DEVELOPMENT REVIEW BOARD REPORT

Meeting Date: October 19, 2023
General Plan Element: *Character and Design*
General Plan Goal: *Foster quality design that enhances Scottsdale as a unique southwestern desert community.*

Scottsdale Gold Bullion and Coin 1-DR-2023	Request for approval of a site plan, landscape plans, and building elevations for a new commercial building totaling approximately +/- 13,300 square feet.
---	--

ATTACHMENT #11
(Non-Action item elevations for reference)

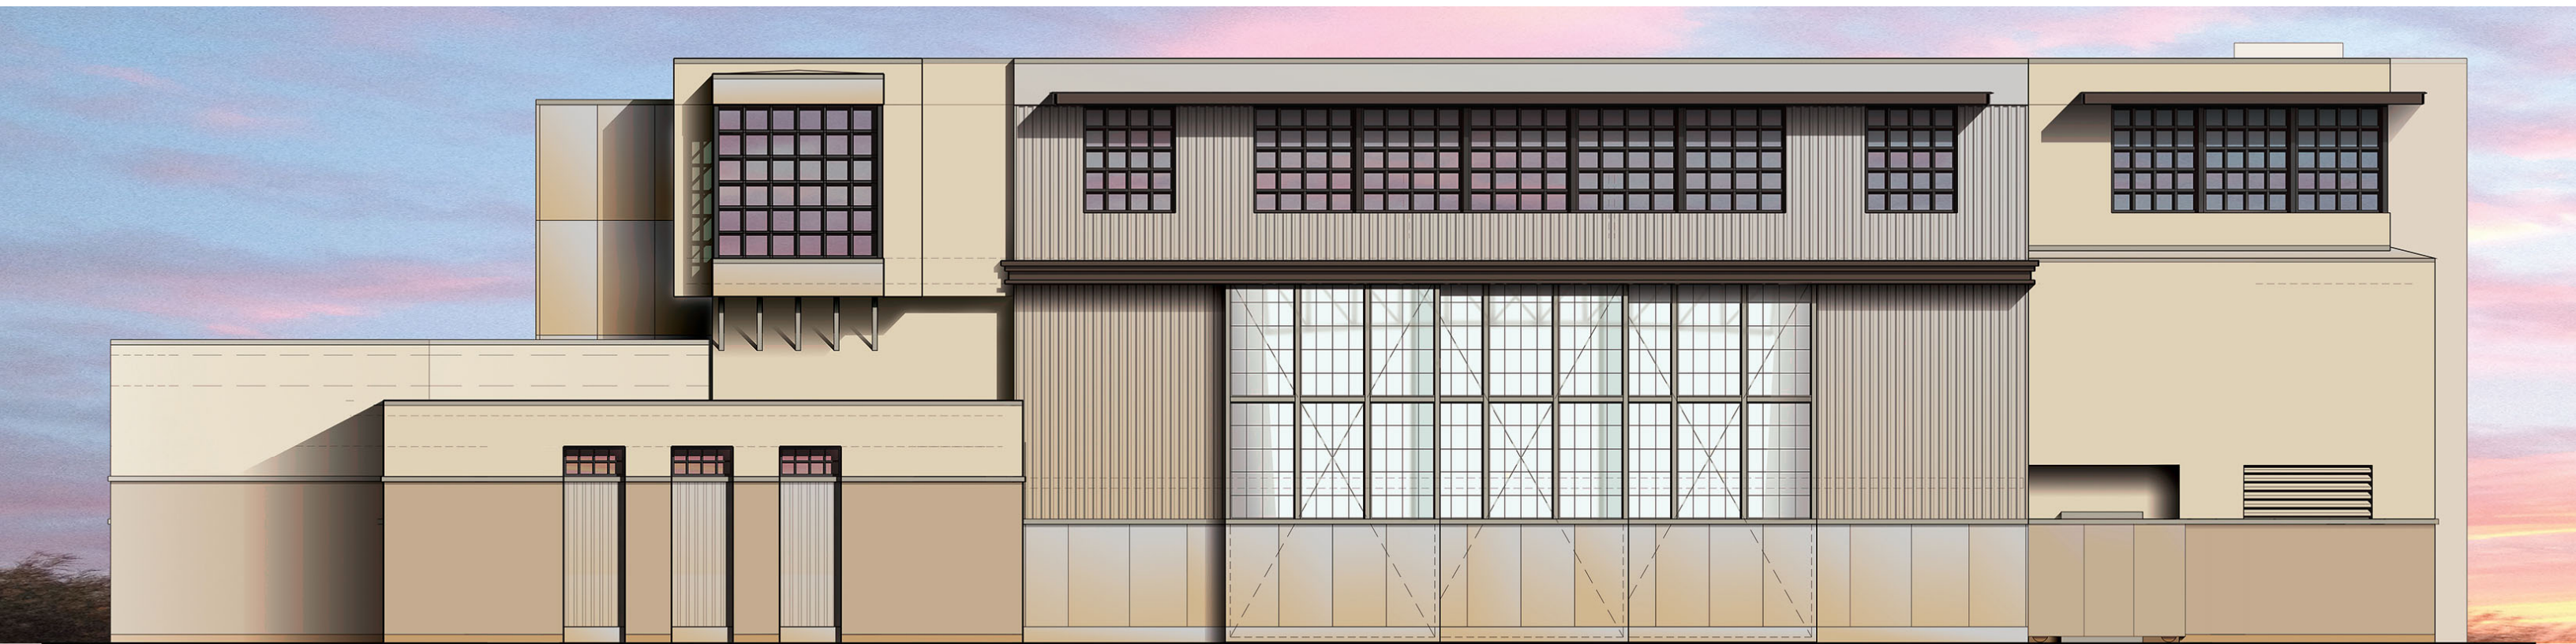
There was a Board member comment that the initial design had a tall, stark, boxy massing. We addressed this comment by breaking up large, stark facades with recesses and projections, which will also help increase the shading of fenestration. The windows at the top level have projecting shade canopies, which help to provide a visual terminus at the top of the structure, so the exterior wall does not simply end at the sky; this will reduce the boxiness.

There was a Board member comment that the building had a lot of articulation and may be highly stylized compared to nearby buildings. The articulation comment was specifically made in reference to the southwest side of the building, which did indeed have a lot of asymmetrical articulation. This created a strong appearance of Abstract Expressionist architecture. We have greatly reduced the articulation and increased the symmetry of the façade. It now creates a smooth and rational connection between the Hayden side and parking lot (primary entrances) side of the building.

The northwest-facing Hayden side of the building is the most prominent in the public realm. To that façade, we made several changes to enhance the balance and increase the overall symmetry. We deleted the corner windows on the west side of the façade and incorporated some articulation to the mass to draw the eye up to the windows on the top level. The base of the building will have aluminum panels to match the tri-partite design used on its other facades. On the east side of this façade, we added a support mass under the large office window removed its cantilever. The large fin wall and the exterior staircase it was screening has been removed. The we have also added clerestory windows and steel siding motifs in recesses to the garage mass.

The second-most publicly prominent façade is the southwest-facing side along the entrance drive. The original design for this façade was highly articulated and asymmetrical. We have drastically reduced the articulation and asymmetry in order to better wrap the design from the front Hayden side around to the back parking lot side, where the building entrances are located. We have also incorporated the aluminum panels along the base to visually link the facades. Decorative bas-relief medallions have been removed.

The third-most publicly visible façade is the southeast side that faces the parking lot. This side contains the primary entrances for the building. We deleted the decorative bas-relief medallions.
